GULF STATES UTILITIES COMPANY

March 1, 1985
RBG- 20,270
File No. G9.5, G9.8.6.2

River Bend Station - Unit 1
Docket No. 50-458

Enclosed is the Gulf States Utilities Company (GSU) response to the letter from Mr. A. Schwencer (NRC) to Mr. W. J. Cahill (GSU) dated January 25, 1985. Attachment 1 provides a summary of each response to your questions and comments on pool dynamic loads for River Bend Station (RBS). Enclosure 1 provides revised pages, tables and figures from the Final Safety Analysis Report (FSAR) which supports the responses in Attachment 1. These revisions to the FSAR will be included in a future amendment and supply the requested information necessary to close-out Safety Evaluation Report (SER) Outstanding Issue No. 7.

FIGURE 6A.5-1

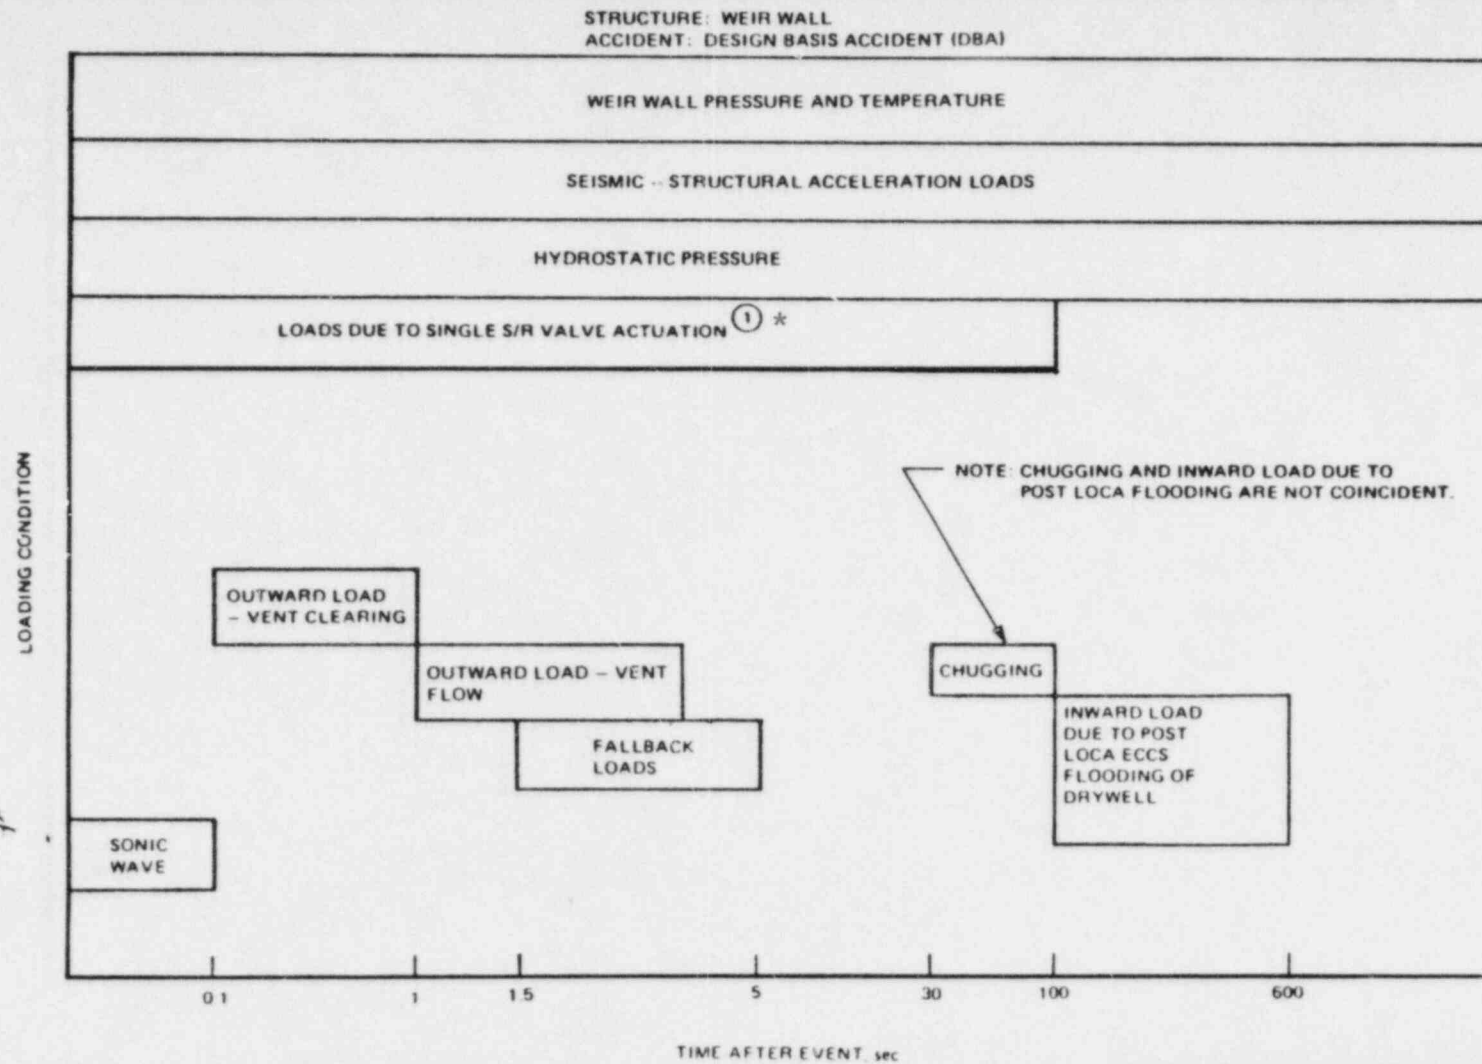
- (i) Figure 6A.5-1 (corresponding to GESSAR Figure 42) does not contain the Figure 42 comment regarding the SRV & drywell air carryover load combination. Please explain.
- (ii) Same question for Figure 6A.6-1 (corresponding to GESSAR Figure 48).

- (i) Figure 6A.5-1 has been revised to add the asterisked note (*) that appears on the corresponding GESSAR Figure 3B-42.
- (ii) This question was withdrawn by the NRC (Mel Fields) in a telephone conference Monday, January 28, 1985.

* Add S/R dynamic load to static load due to drywell air purged to containment

FIGURE 6A.10-5

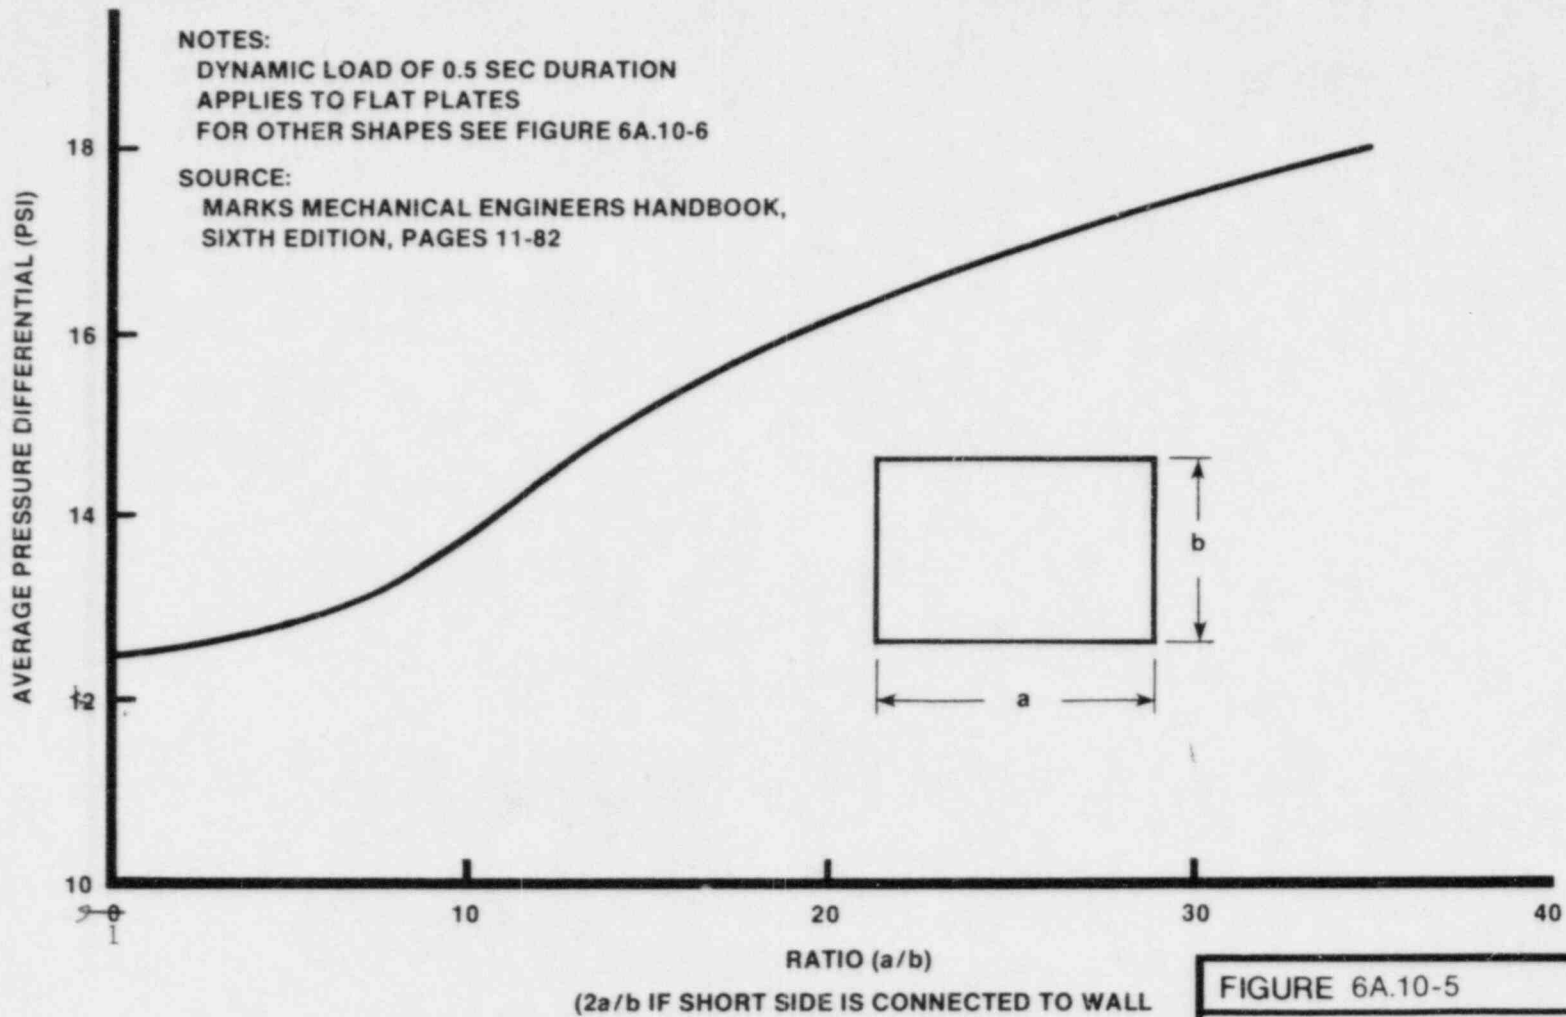
The abscissa of Figure 6A.10-5 must start at 1.0 and not at 0 as drawn. Note that the lowest pressure drag is observed on a square plate, $a/b = 1.0$ and it increases as this ratio becomes either larger or smaller than 1. Thus, in the limit of $a/b = 0$, one has an infinite strip with a drag coefficient of 2.0 and a pressure differential of 21.6 psi (for $V = 40$ ft/sec). The figure does not show this.

See revised Figure 6A.10-5 contained in Enclosure 1. The zero (0) is changed to one (1).

Fig. 6A.10-7

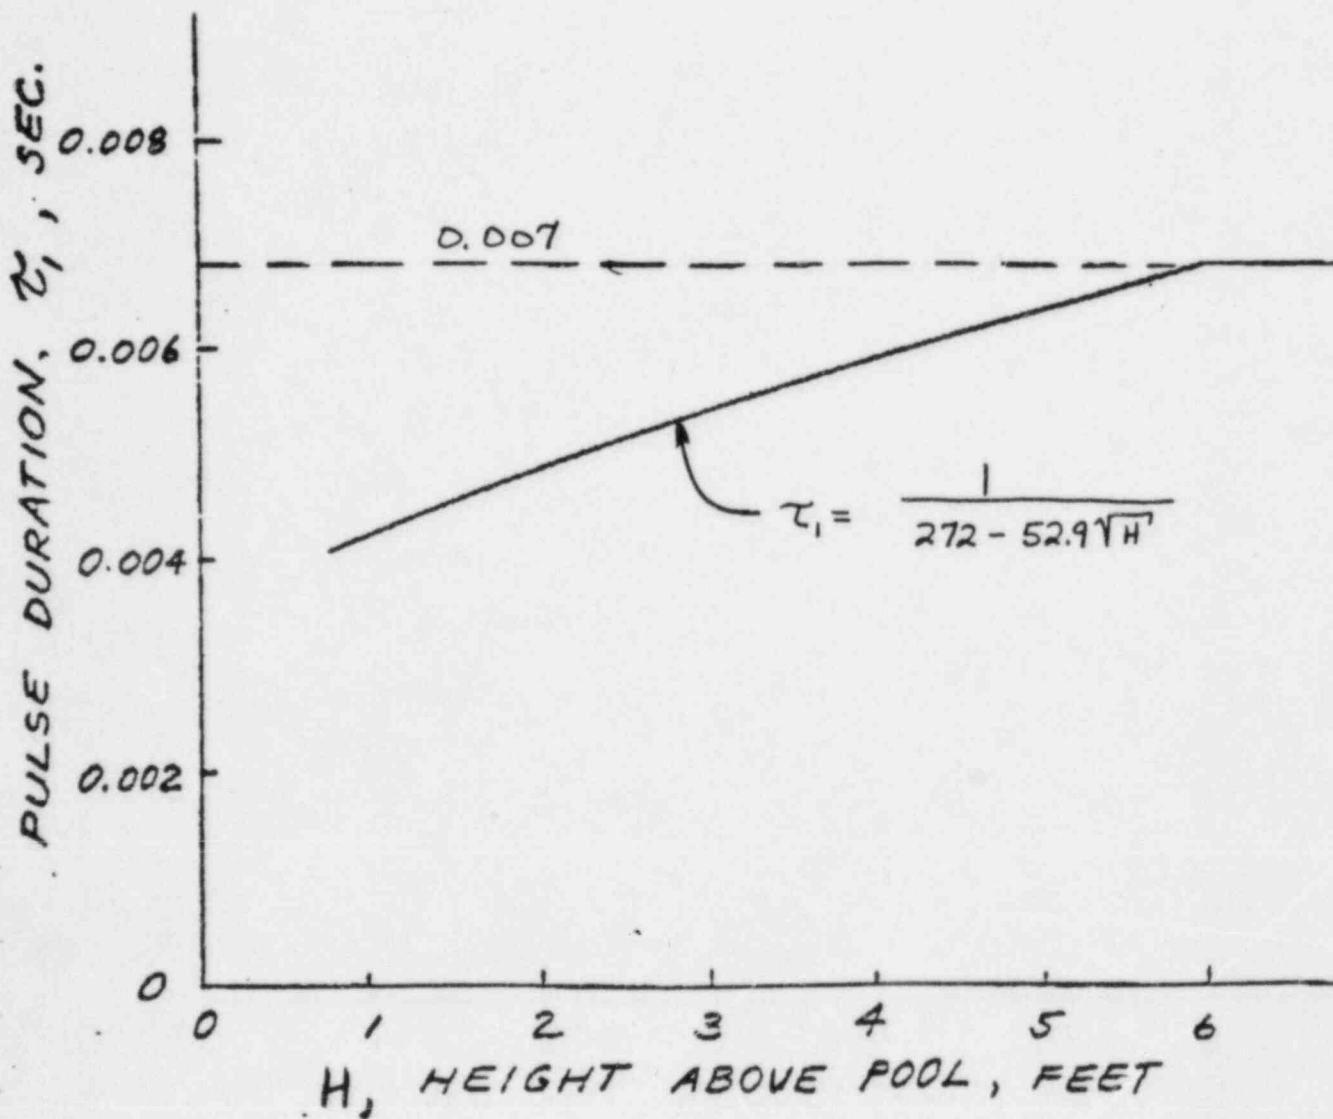
The pressure amplitude for short ($x < 4$ ft) circumferential structures is not determined correctly. The method outlined can lead to an incorrect impulse of impact. Please refer to "Suggested Acceptance Criteria for Impact Loads on Short Mark III Structures Close to the Pool" by G. Maise, February 15, 1984.

For radial and circumferential structures within 6 feet of the pool surface, the pressure amplitudes are first adjusted based on Equation 3-7 of NUREG-0978. The pulse durations are reduced based on procedures described in G. Maise's "Suggested Acceptance Criteria for Impact Loads on Short Mark III Structures Close to the Pool", February 15, 1984. The final impact pressure is then found by equating the impulse for the 0.007 second duration with that for the reduced pulse duration:

- a. For structures within 6 feet of the pool surface, the pulse duration τ_1 is given in Figure 6A.10-7.
- b. For structures less than 4 feet in length, the pulse duration τ_2 is given in Figure 6A.10-8.
- c. For structures both less than 4 feet in length and within 6 feet of the pool surface, the pulse duration is given by:

FIGURE 6A.11-1

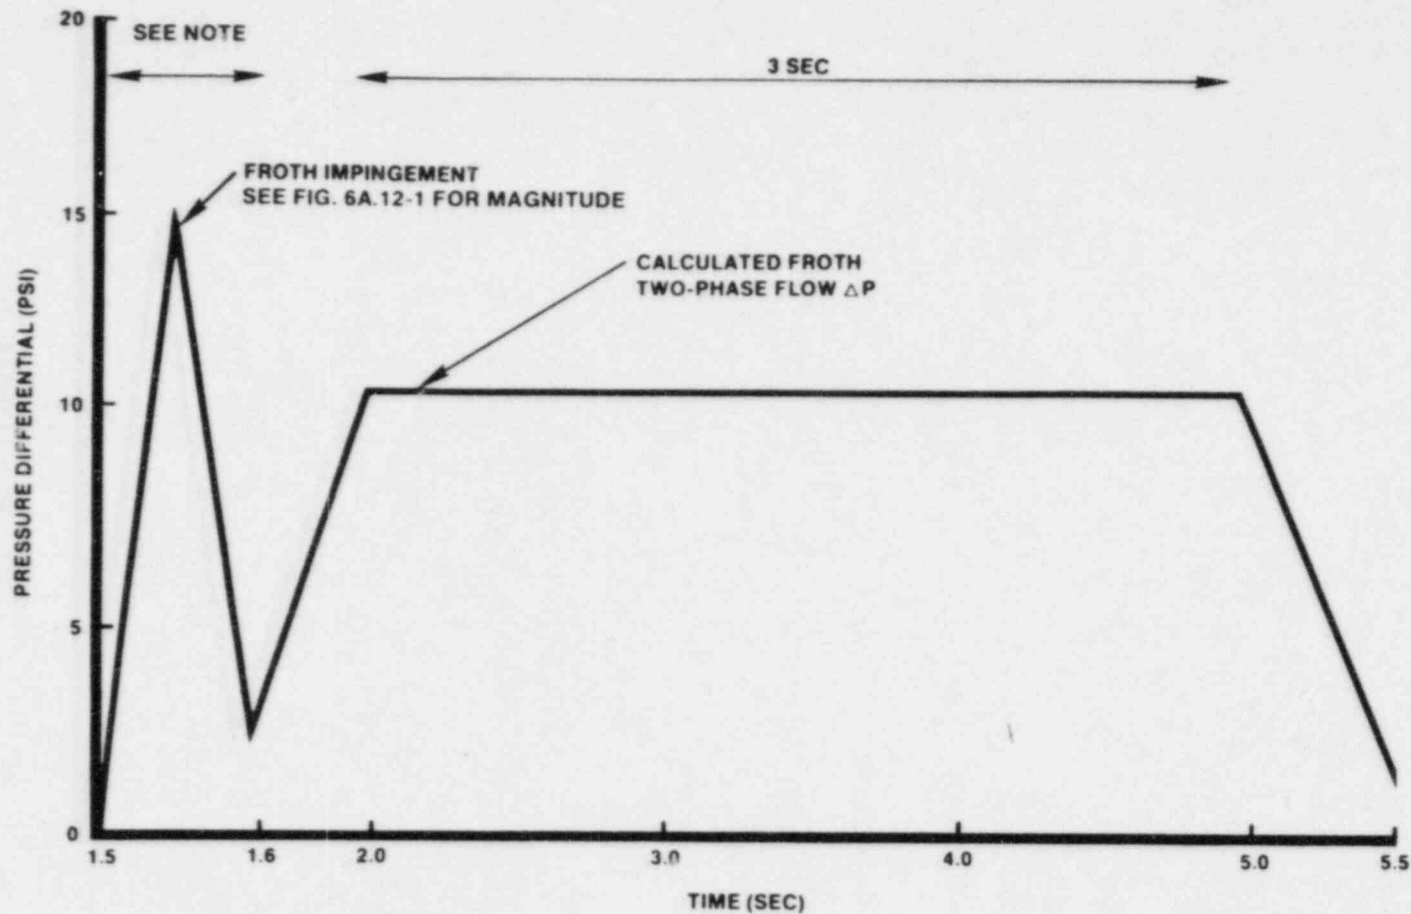
The note on Figure 6A.11-1 indicating that the pulse duration for impact cannot be less than 50 msec, is misleading. This applies only to radial structures that span the entire pool annulus. The statement in the text on page 6A.12-1 is correct, however, the use of Figure 6A.11-1, by itself, can lead to errors.

See revised Figure 6A.11-1 contained in Enclosure 1. The note has been clarified.

IMPACT
 NOTE: DURATION CHOSEN TO GIVE THE MAXIMUM DYNAMIC LOAD FACTOR,
 BUT NOT LESS THAN 50 MSEC FOR EXPANSIVE STRUCTURES
